Project: Request for approval of a master sign plan for Danor Plaza Shopping Center located at 401-409 Maple Avenue, E, and 116-124 Branch Road, SE, (Docket No. BAR-22-13), in the C-2 General Commercial zoning district; filed by P. Daniel Orlich c/o Jerry Forker.

Docket No.: BAR- 22 - 13

DATE: March 21, 2013
TO: Board of Architectural Review
FROM: Matthew J. Flis, Deputy Director
RE: Item No. 10

Danor Plaza Master Sign Plan- New paint color for sign cabinets and monument sign

EXISTING SIGNS – 03.11.13 - BAR 22-13

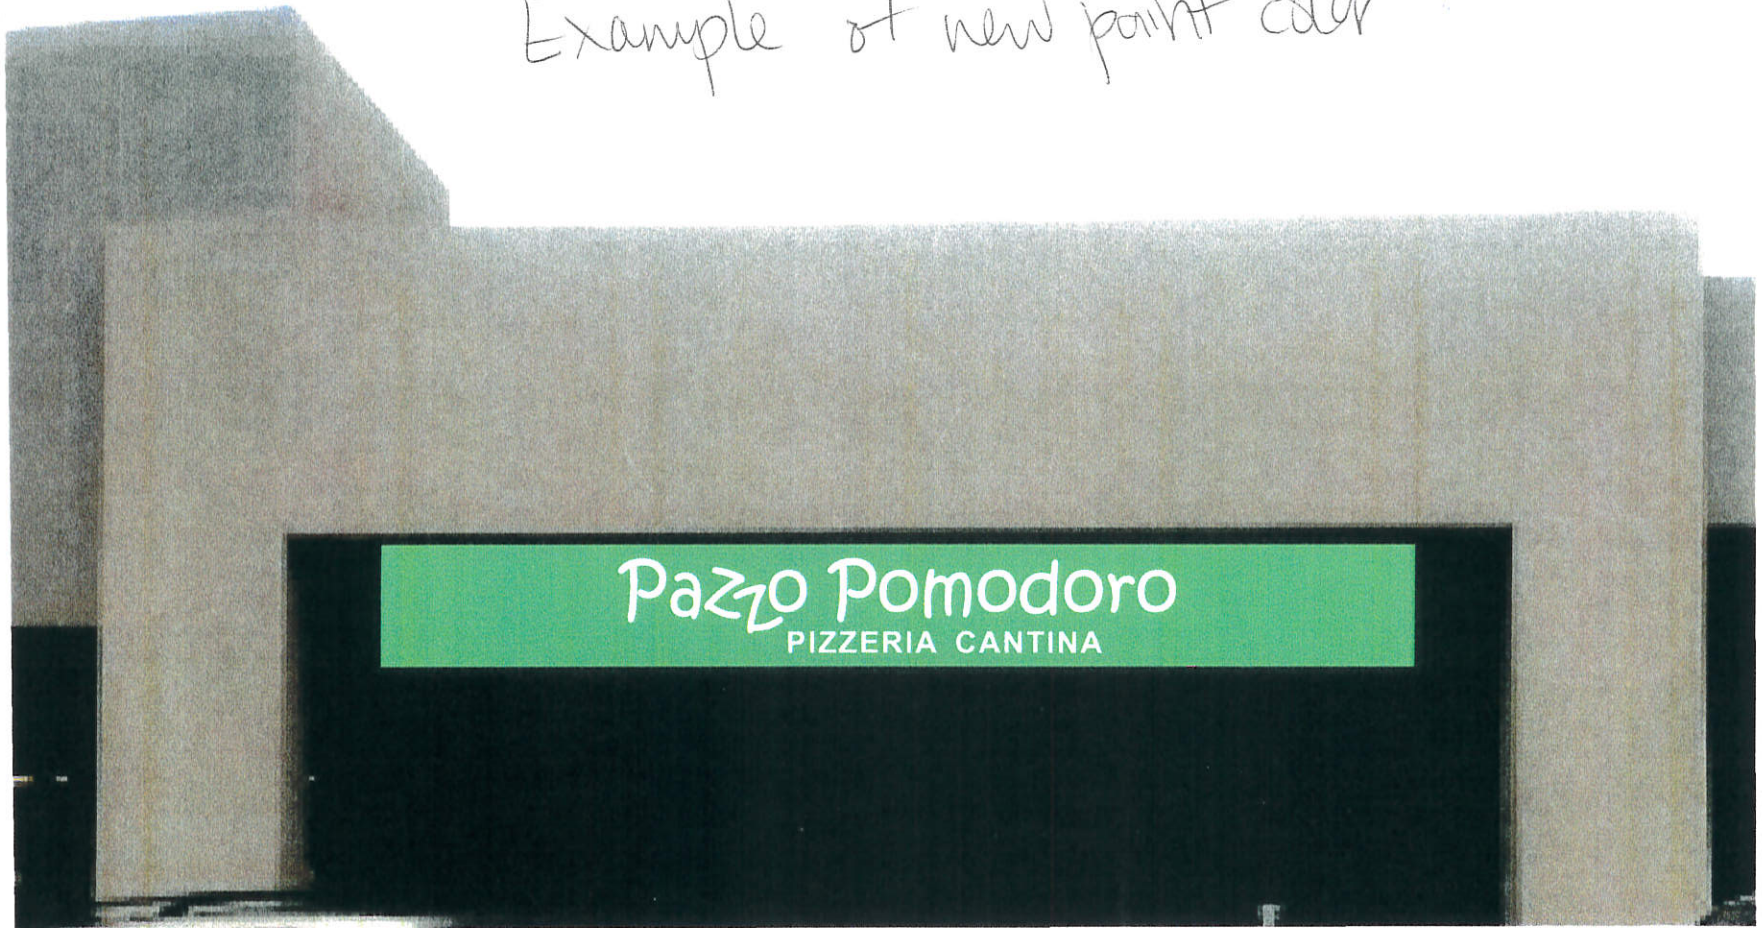
In addition, the applicant proposes to paint portions of the existing freestanding sign in the color green. The new paint would apply to the upper portion of the sign which reads "Danor Plaza" and the lower base, as indicated in the submittal. Staff recommends that, in addition to the sign face, the sign edges also be painted green to match.
